NewCAL

Design Review Committee

May 10, 2023

DRC Responses

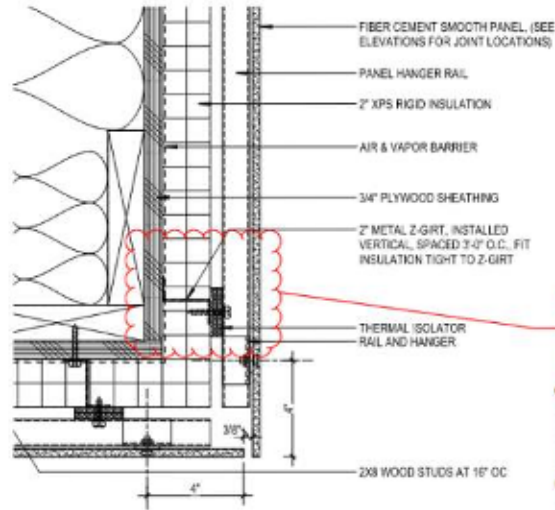
A0006/EW3-1: Would it be better to have thermal isolator located at the sheathing?

BH+A:
Will adjust to face of Sheathing

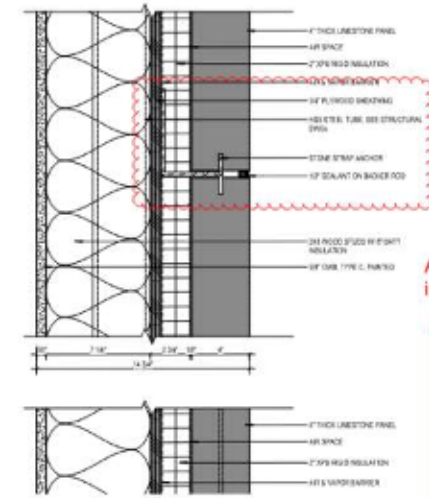
A007/EW4-1: Don't see thermal isolator behind "stone strap anchors"

BH+A:
Will include thermal isolator at face of sheathing if applicable

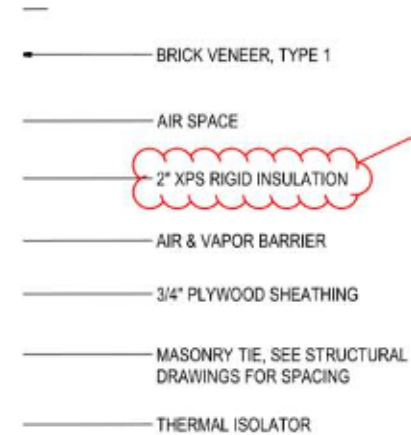
A006/EW2-1 (TYP): what material is this? how are joints, penetrations, terminations handled? Is it continuous around all six (6) sides?

A006/EW2-1 (TYP): using low GWP XPS?

BH+A:
Air Vapor Barrier to be Carisle CC-705 series, non permeable, rubberized sheet product or similar.

BH+A:
Will explore Low Global Warming Potential XPS product such as Green Guard LG series (Blow agent blend target of 50)
